Midway City Council
15 January 2019
Regular Meeting

Homestead Villas /
Preliminary Approval

NAME OF PROJECT: Homestead Villas: Phase 1 of the Homestead Resort Master Plan

Subject: **The Homestead Villas Plat A and B; Preliminary Review**

THE HOMESTEAD
HOMESTEAD VILLAS
DRIVEWAY PLAN AND PROFILE

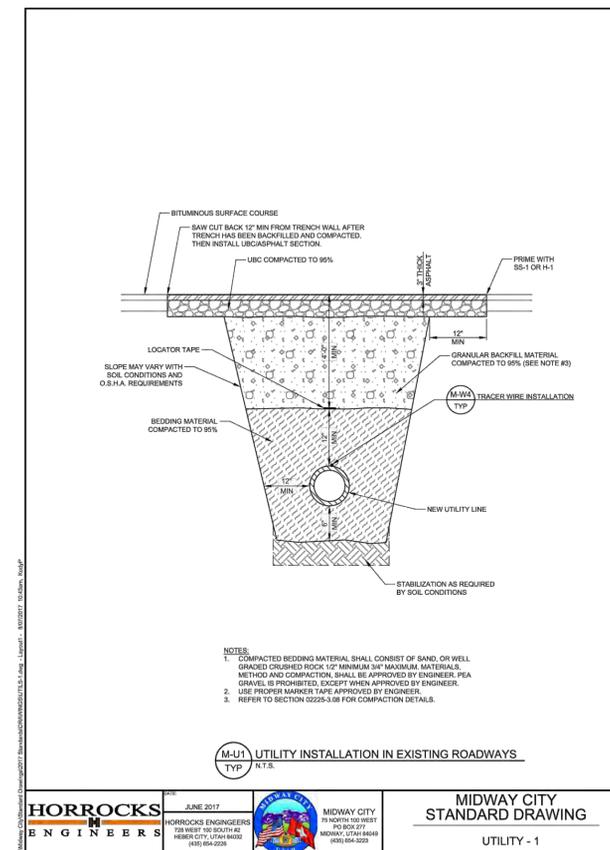
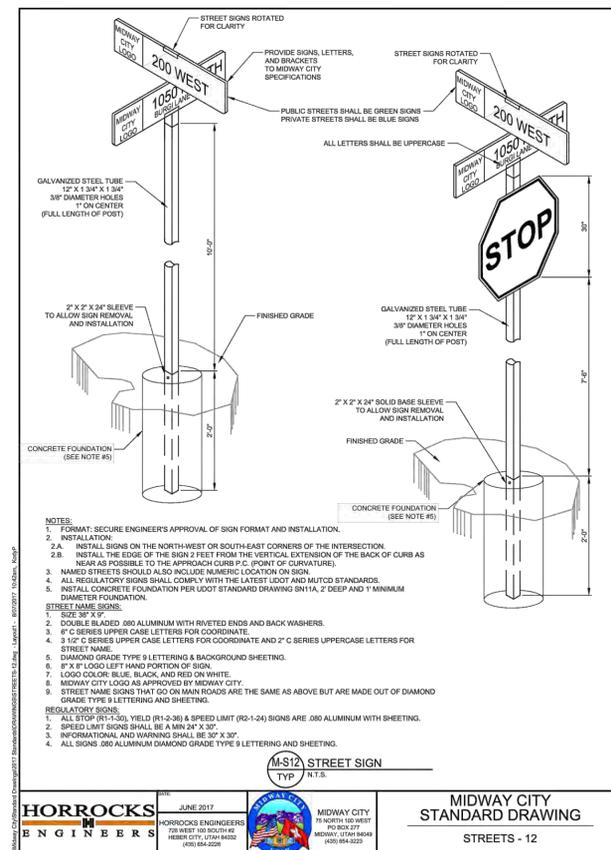
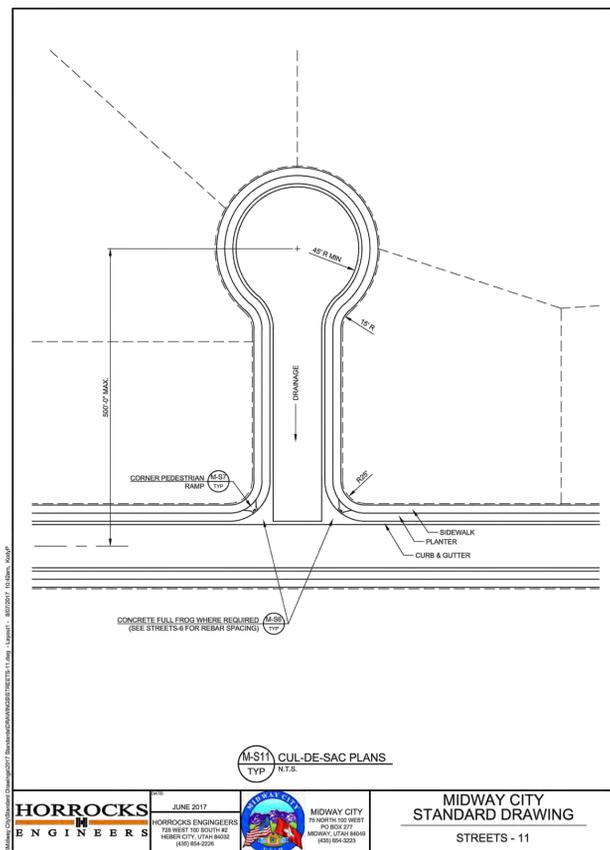
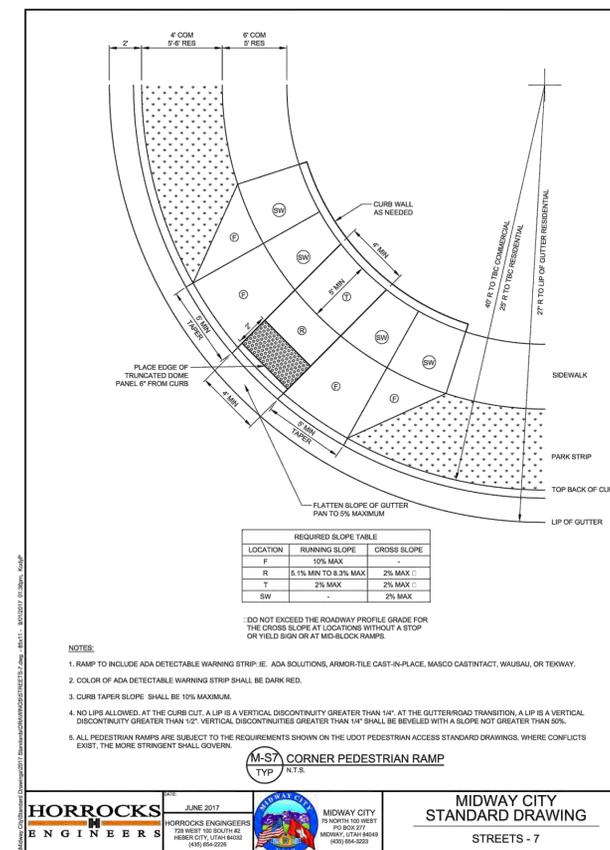
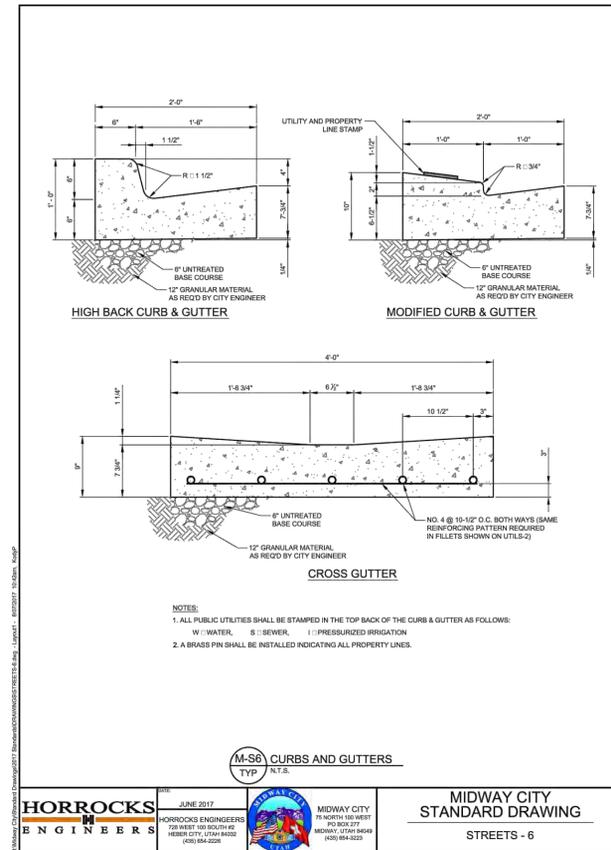
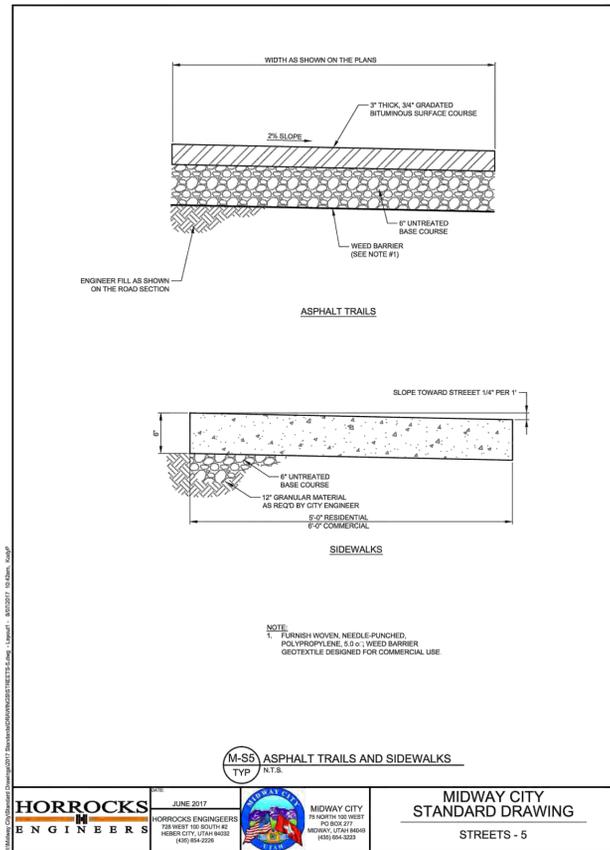
- This is the first phase of the Homestead Resort Master Plan. A retaining wall is shown across the private drive from lot 1. The note states "Rock Wall designed by others". It should be clear who is designing the rock wall and when the rock wall will be installed. Can the road be constructed without the rock wall? What is the height of the proposed rock wall? The proposed landscaping should be included within the bond.

- To better protect the erosion of the existing area, the 20' private road within Plat A should have curb & gutter installed on each side of the road.
- A hammer-head turn-around is proposed at that the end of the private drive.
- Lot 4 as currently shown in Plat B has an easement strip between it and the existing Mountain Springs Drive. This easement should be recorded with the recording of plat B.
- The property boundary of lot 4 is over the existing dirt road connecting the dirt road to Mountain Springs Drive. Will this dirt road be re-located and the connection be continued?

- Discussion in the Midway planning committee meeting in December referred to the extension of Fairway Dr (north) as both a roadway and a private drive. Plans describe the extension as a private road. The summary of the Planning Committee meeting describes it as a driveway. Which is it? And does it make any difference.
- Is the end of the new Fairway extension going to be a hammer head dead end or a cul de sac dead end? The Planning Committee Meeting summary describes it as a cul de sac. In the Planning Committee meeting, a hammer head dead end was discussed and shown on the plan but Wes Johnson would prefer it be a cul de sac dead end. The Links strongly prefers a cul de sac for the reasons below.

- Curbs and gutters on both sides of the private road are necessary to minimize runoff. This was mentioned in the meeting as necessary, but it is not in the meeting summary. How does this affect storm drain calculations?
- We agree with the request by Horrocks that the maintenance gravel road or diversion of maintenance road does not need to be maintained since lots 1, 2 and 3 will now replace the area where the Homestead Golf Course keeps their extra landscape supplies (sand, soil, driving range equipment etc.). If it is still there, the maintenance road will most likely be used by individuals trying to find a shortcut around established roads which will most likely be Bayhill.

THE HOMESTEAD
HOMESTEAD VILLAS
STORM DRAIN PLAN

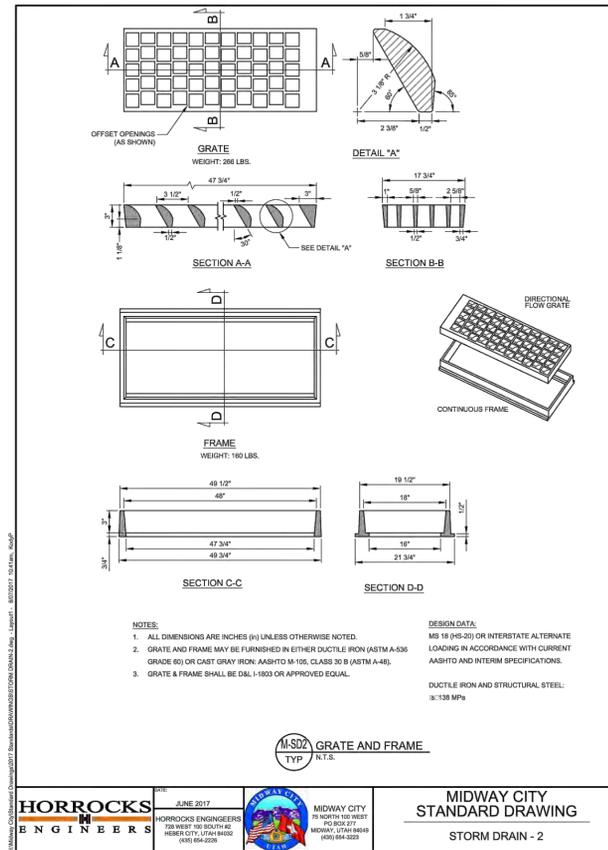
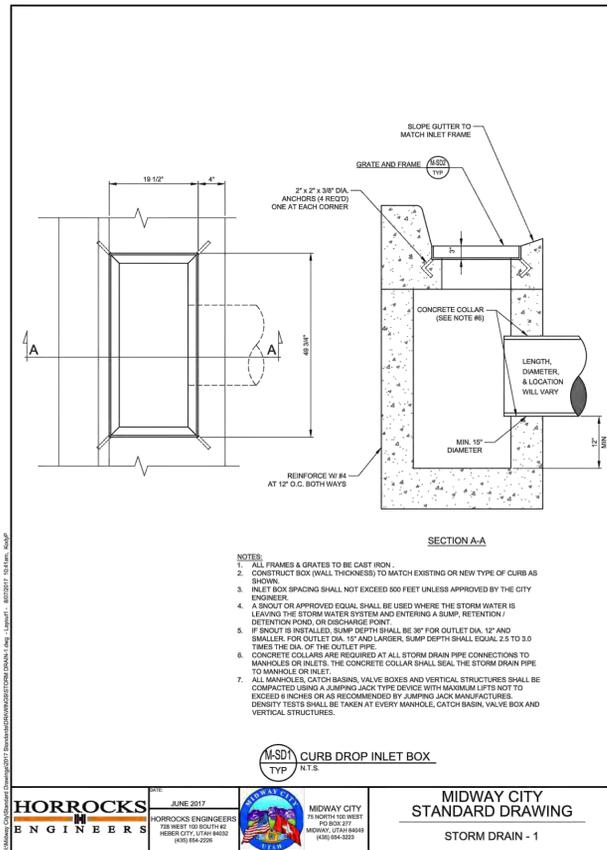
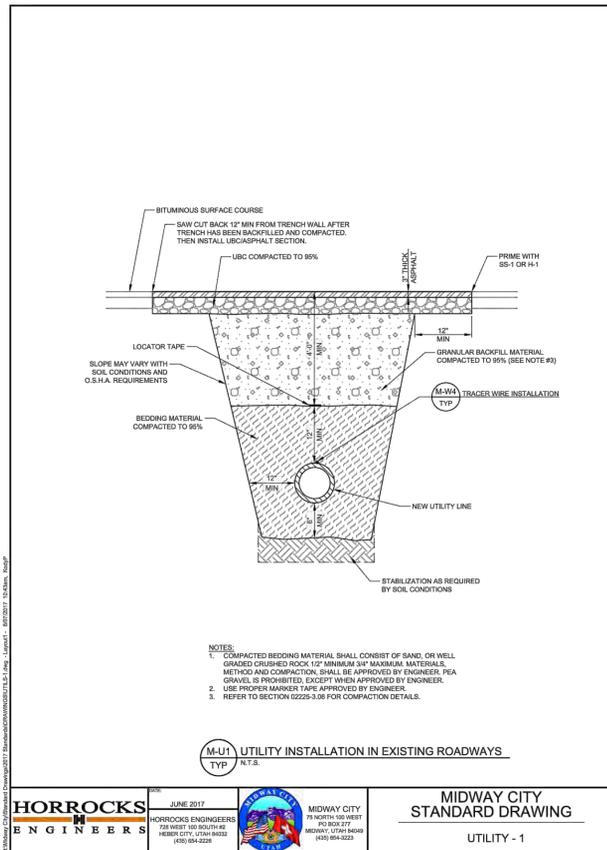
- The proposed storm drain system contains two sumps. With the construction of the additional curb & gutter, the storm drain calculations should be updated. What type of soil will the sumps be constructed in? Is lot 1 proposed to have a basement that the proposed sumps could impact?

- Storm drain sumps should be reevaluated. Recalculate run off calculations and provide for the type of soil sumps to be constructed for the geographical features. Homes east and south of the sumps have basements and/or sharp drop offs. We feel it is very important to determine where the water will drain to and from the sumps.
- How will oil and other hazardous liquids runoff be handled if sumps overflow? Horrocks Engineers recommend a study be undertaken.
